# MISSISSIPPI POWER & LIGHT COMPANY

SUBJECT: Grand Gulf Nuclear Station  
Unit 1  
Docket No. 50-416  
License No. NPF-13  
File 0260/L-860.0  
Organization of Grand Gulf  
Management and Staff,  
Supplemental Information  
AECM-84/0360

SUPPLEMENTARY INFORMATION ON  
THE ORGANIZATION SUBMITTAL OF  
MAY 24, 1984

Figure 1

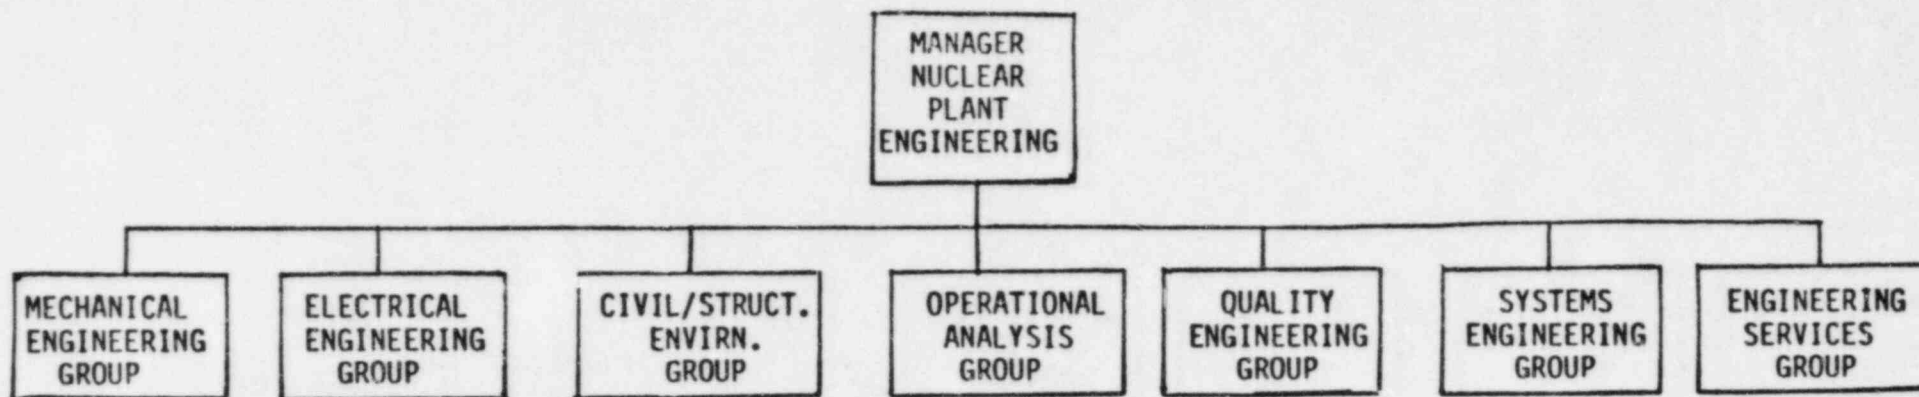
The Nuclear Plant Engineering organization has changed by the addition of two principal engineers as described above. Figure 1 shows the NPE organization.
